Objet : Dépôt de documents – Projet de parc éolien de la Rivière-du-Moulin

Communications et échanges de documents entre le promoteur et le Ministère de la Défense Nationale concernant le projet éolien de la Rivière-du-Moulin

Subject: Rivière-du-Moulin Wind Farm - WTA-0048

Rivière-du-Moulin Wind Farm

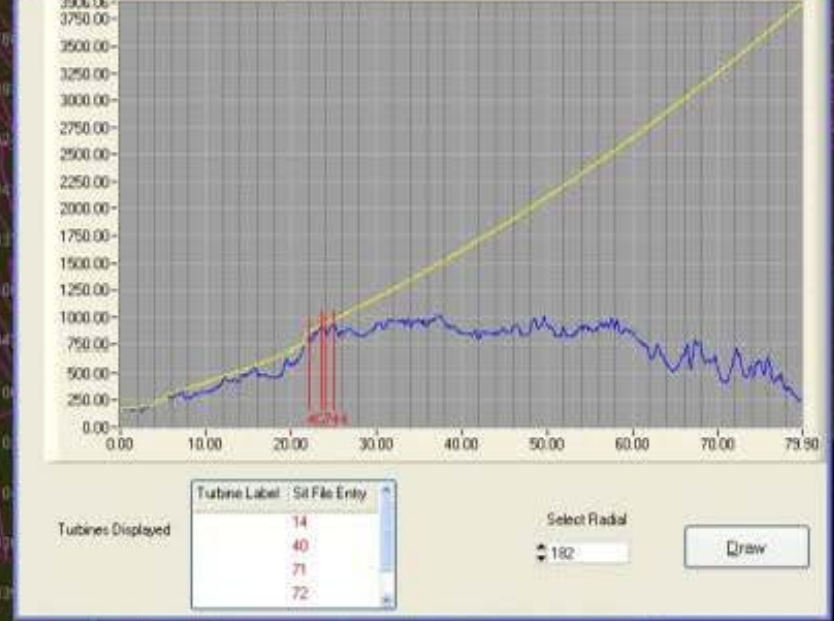
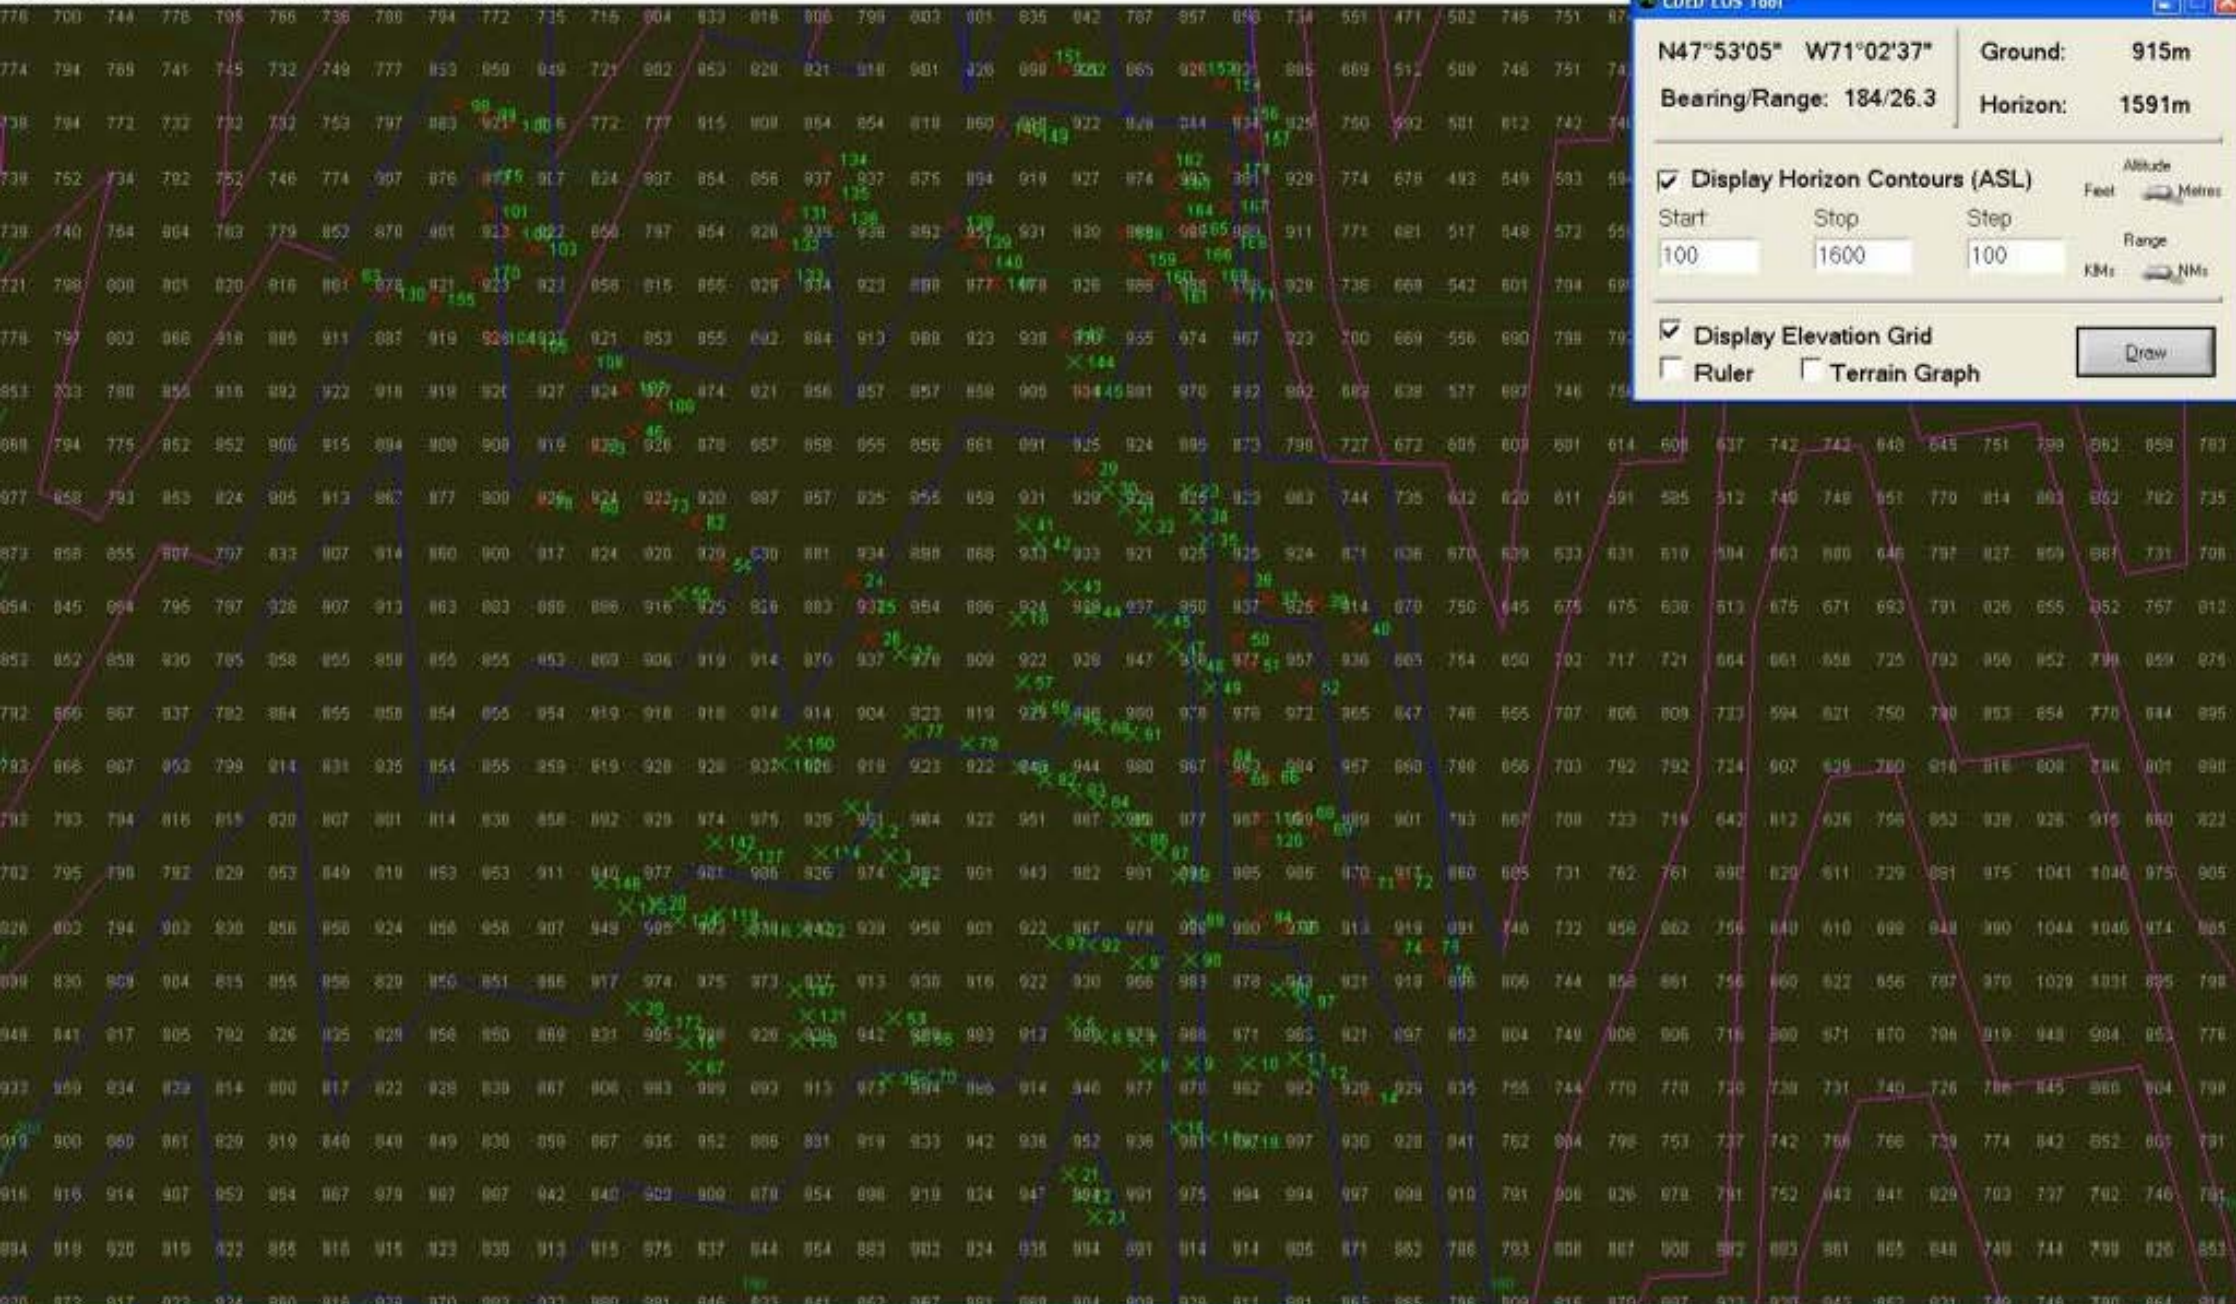
Here are some of our findings thus far wrt this site.

The next doc, 'Moulin Range In' is in essence a close in view of the turbine locations as mapped on our LOS tool. The green and red X's are the turbines with the turbine # beside it (note: this numbering scheme may not match what we received from you however, it will exactly match the Lat/Long locations and numbering scheme listed in the 'Moulin Results' doc). The jagged pink lines are the radar horizon or LOS at various altitudes. Where this pink line turns blue is an indication of radar interference.

Rivière-du-Moulin Wind Farm

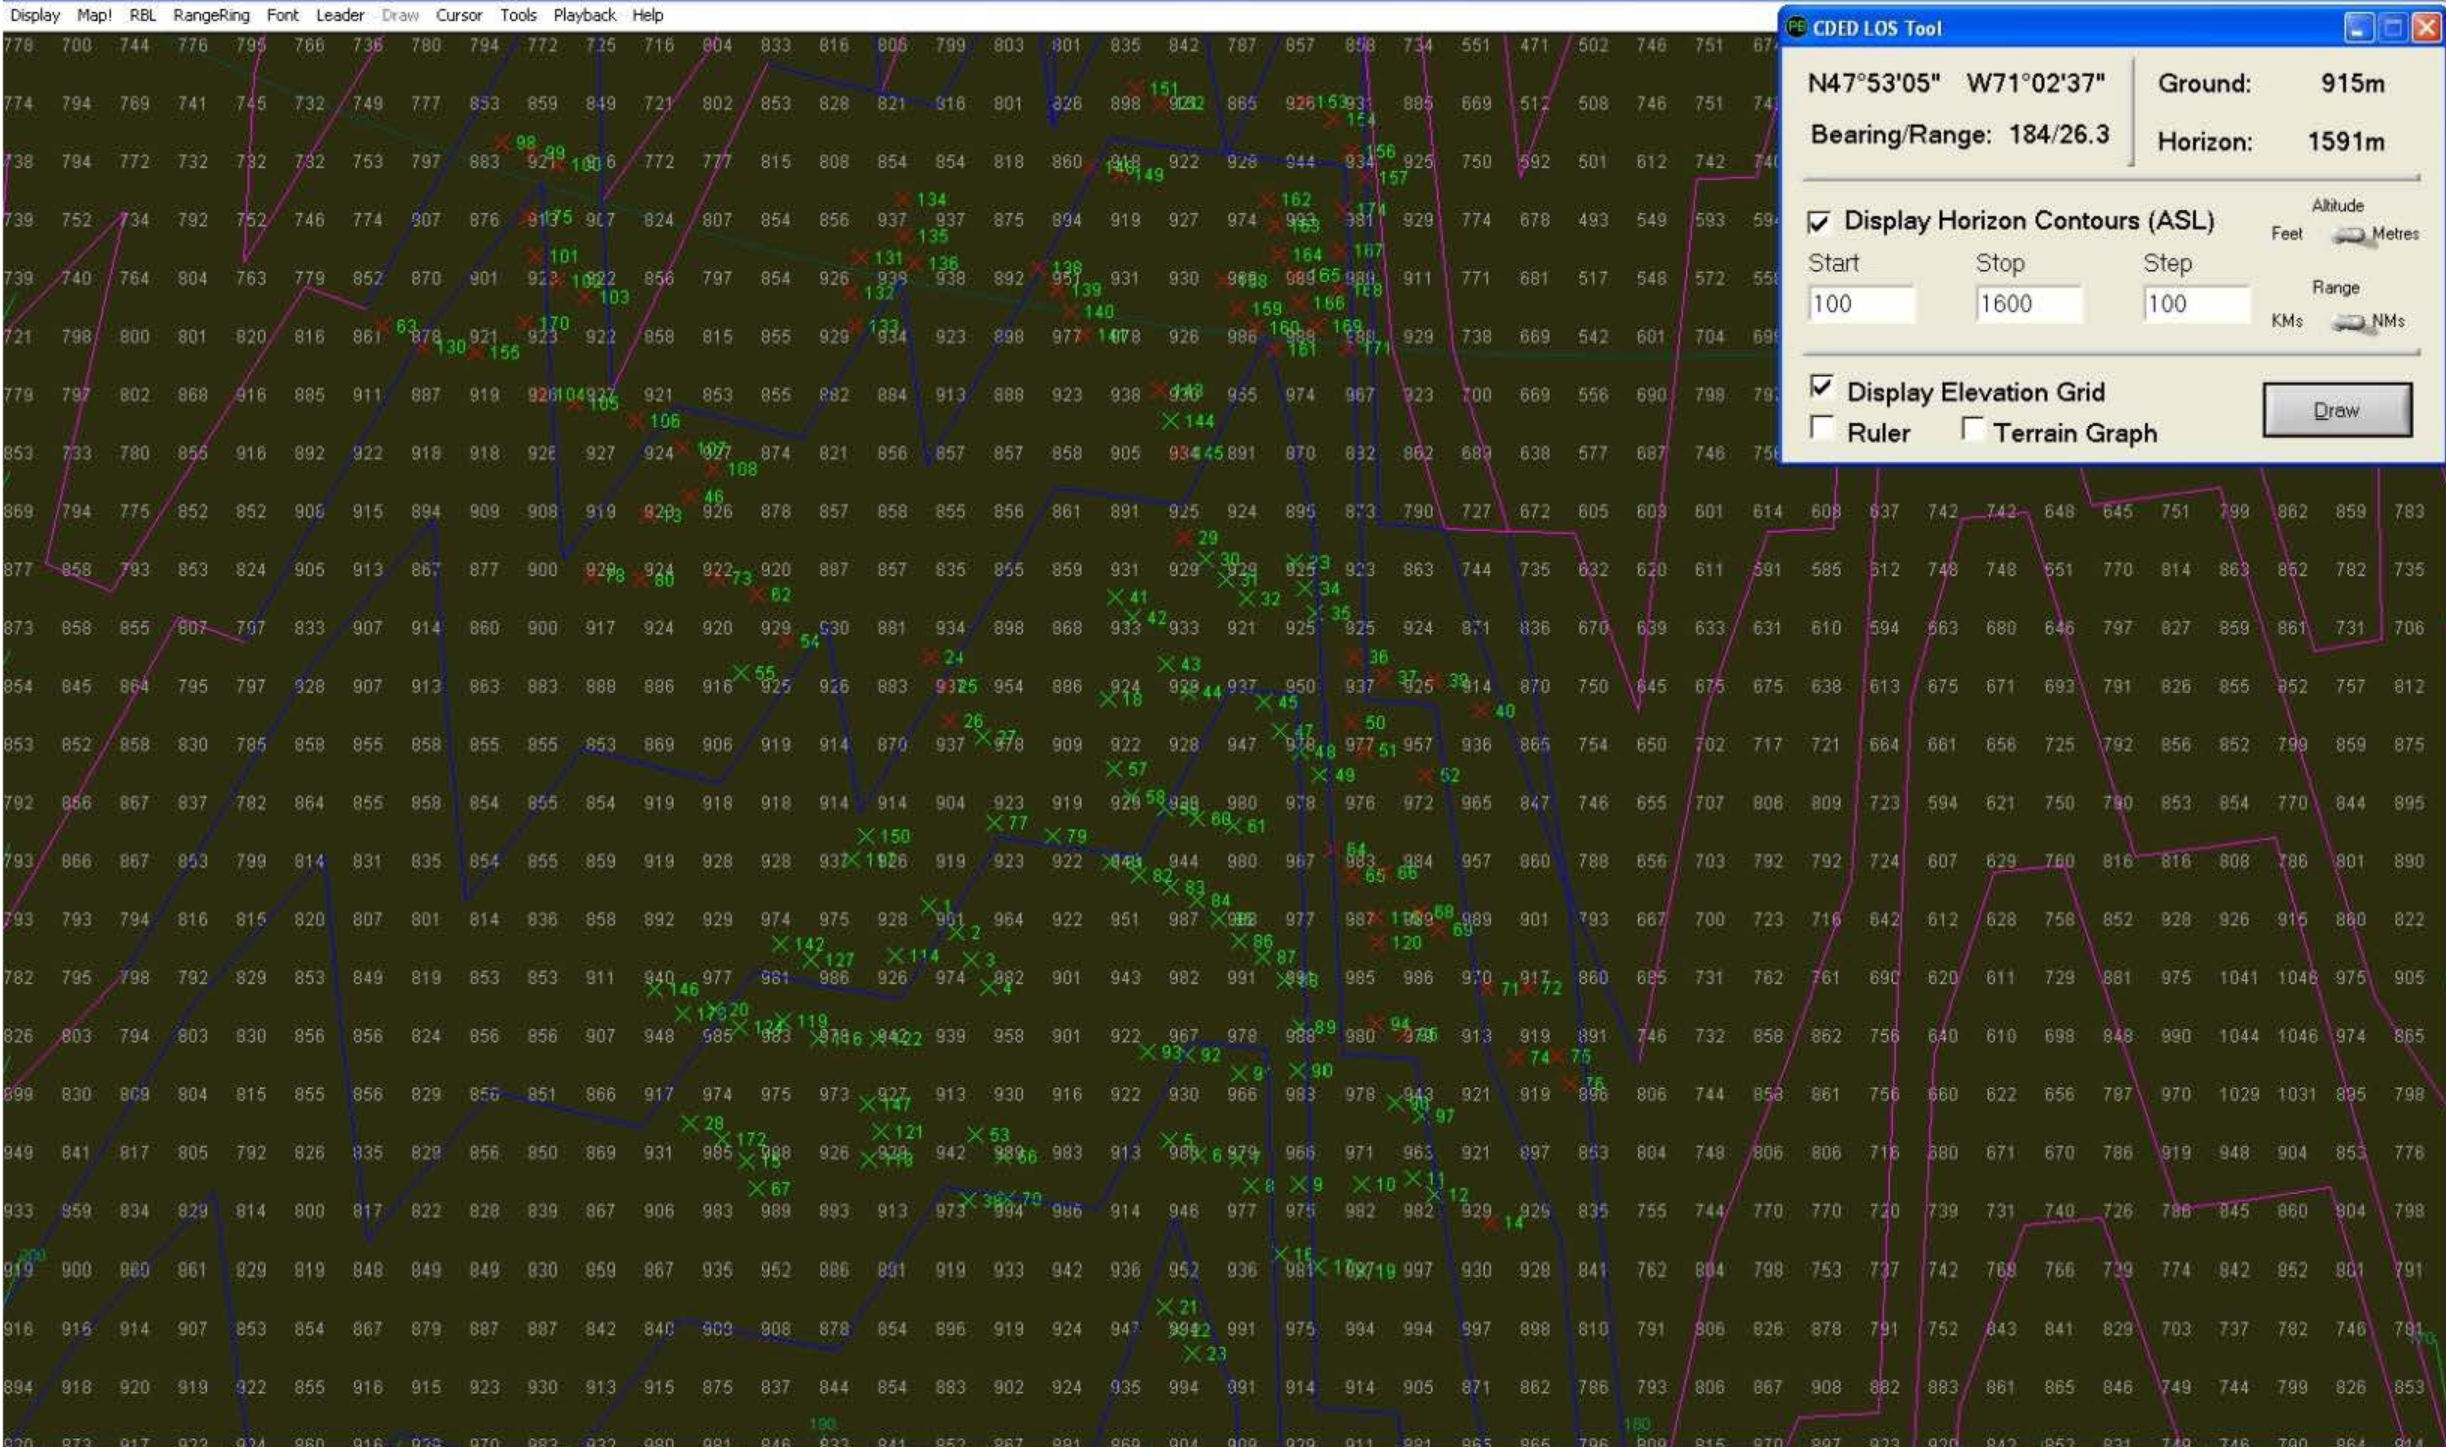
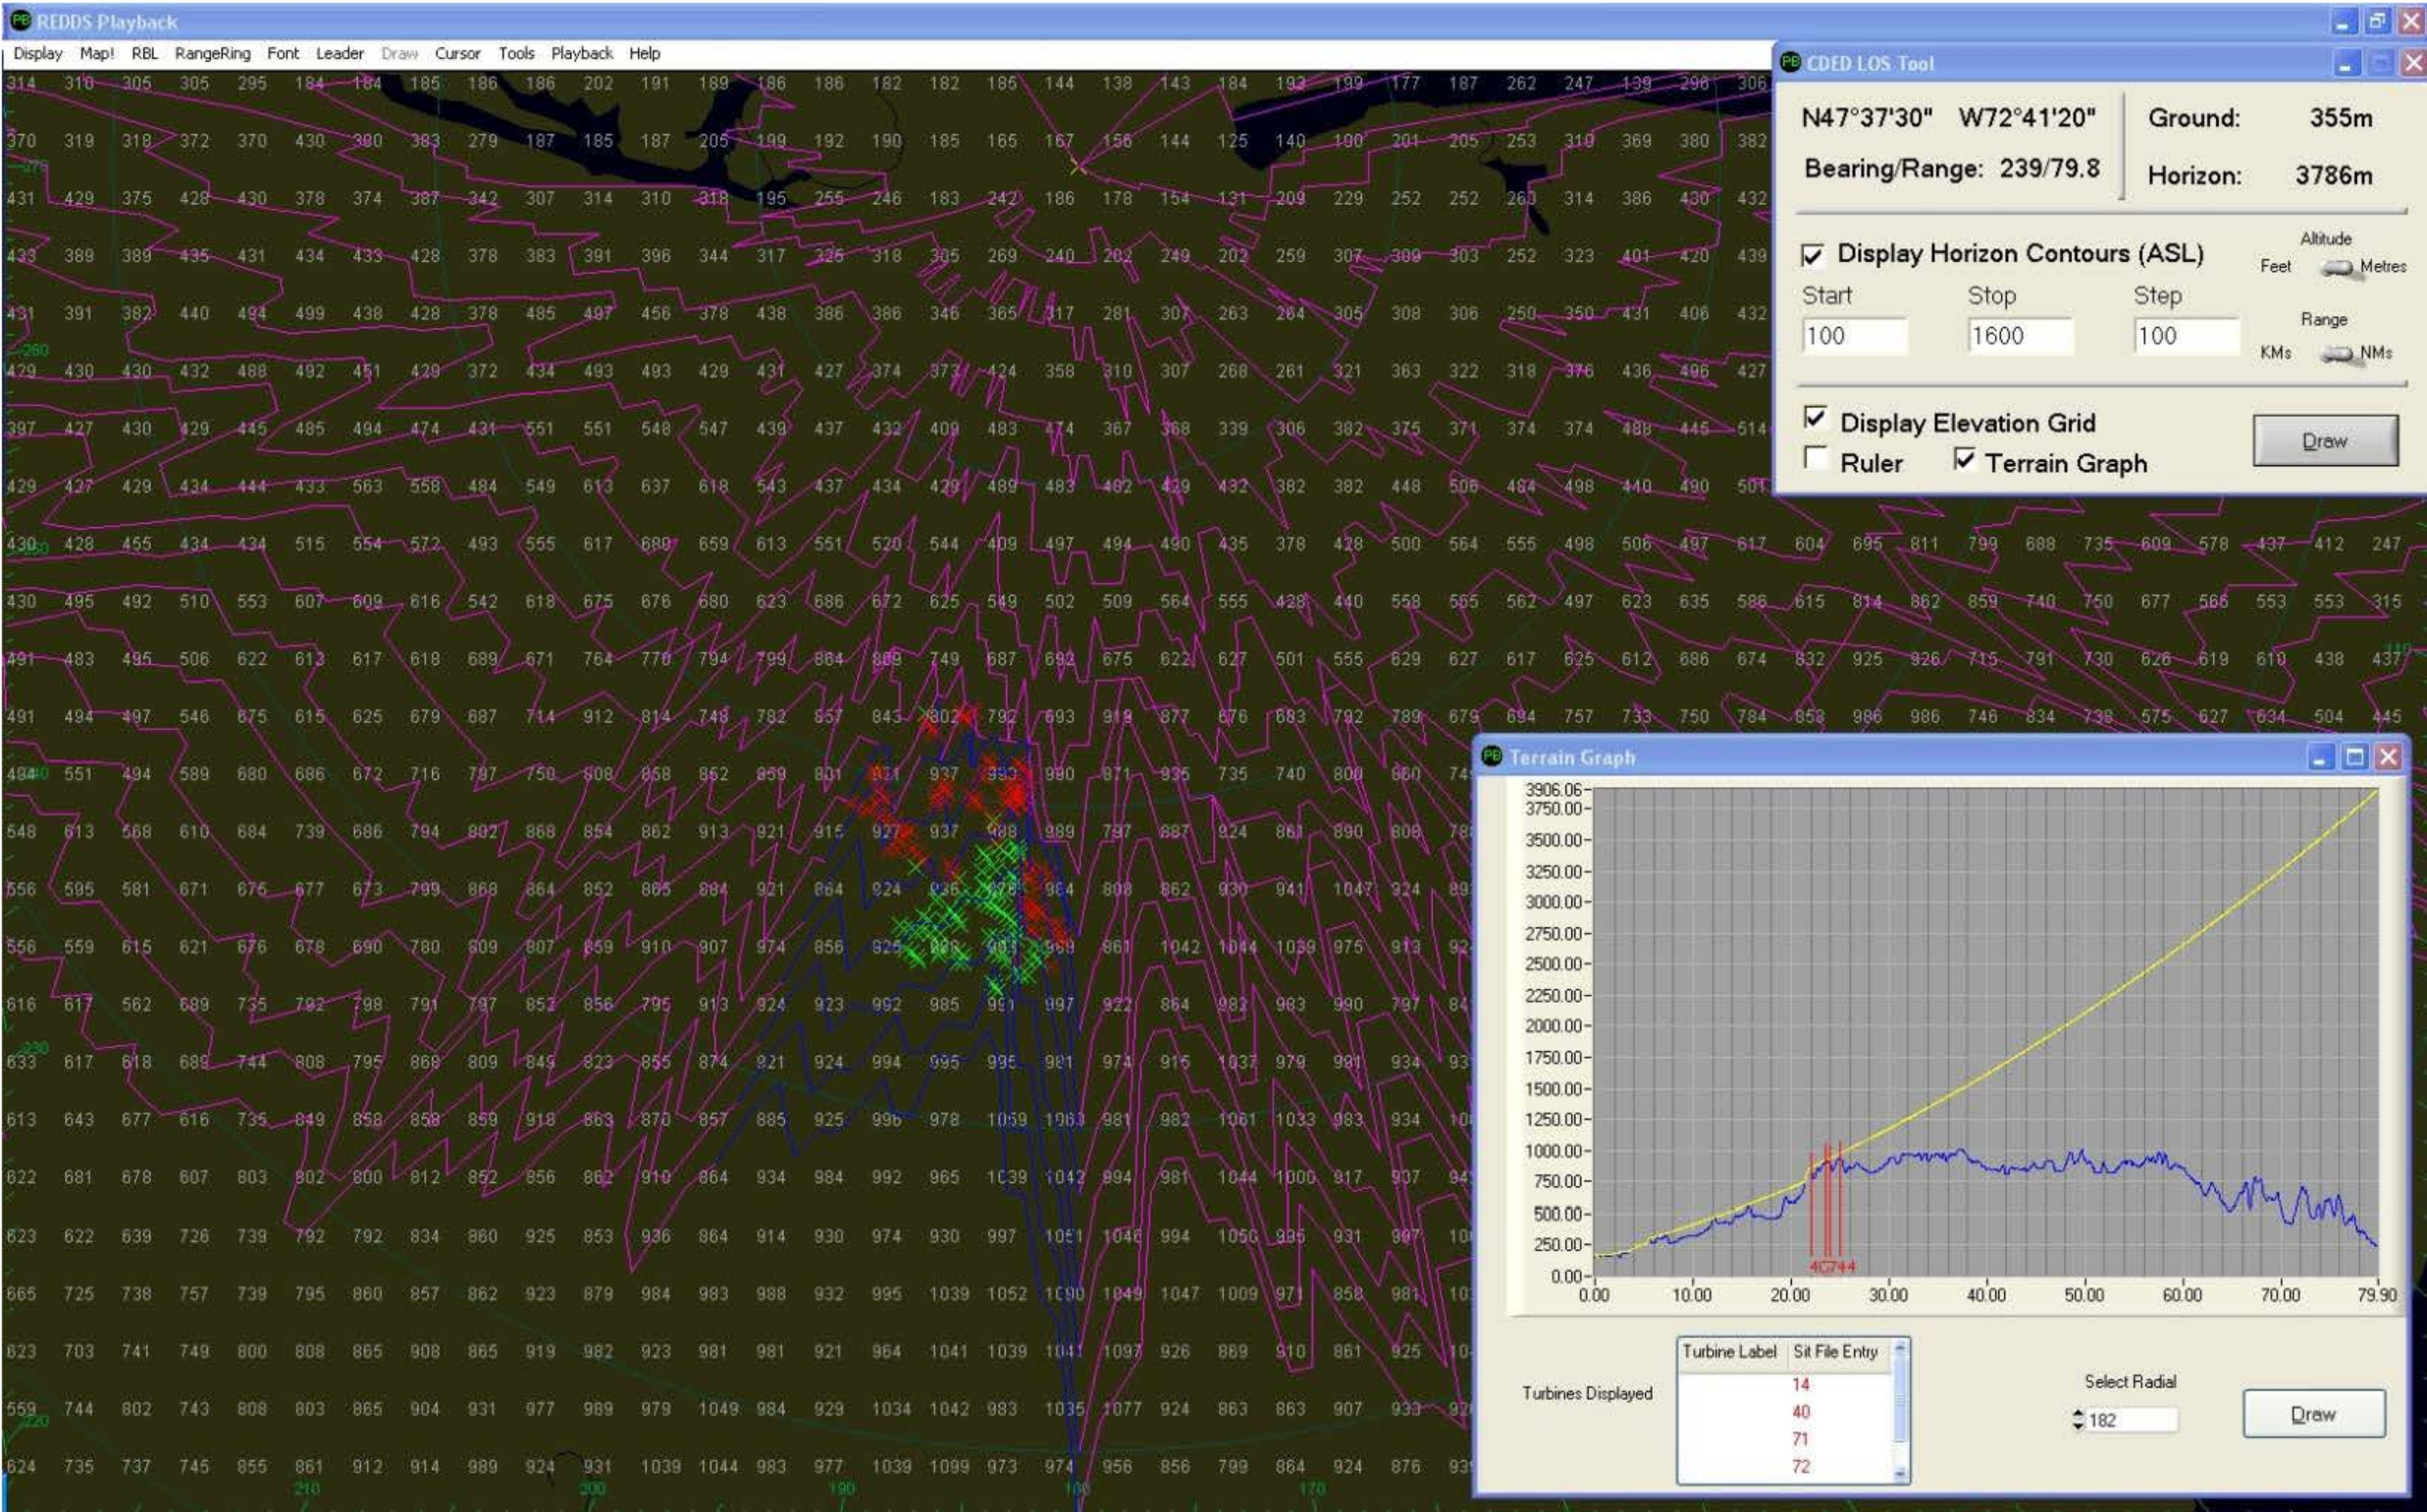
The last doc 'Moulin Range Out' is similar to the previous image but from an elevated point of view. The centre from which the pink (blue) horizon lines emanate is the Bagotville radar. Red X's are the interfering turbines while green X's are in the clear. This image gives a good indication of the swath of radar coverage that will be impacted by the Rivière-du-Moulin Wind Farm site. Also, as part of this image is a tool we use called a 'Terrain Graph'. This depicts a cross sectional lay of the land on a specific radial from the radar. In this case it is the 182 degree radial from Bagotville. The yellow line is the viewable radar horizon, the blue line the underlying terrain and the red spikes are actual turbine locations along that specific radial. If the turbine penetrates the yellow line they are red if they do not they are green (not seen here).
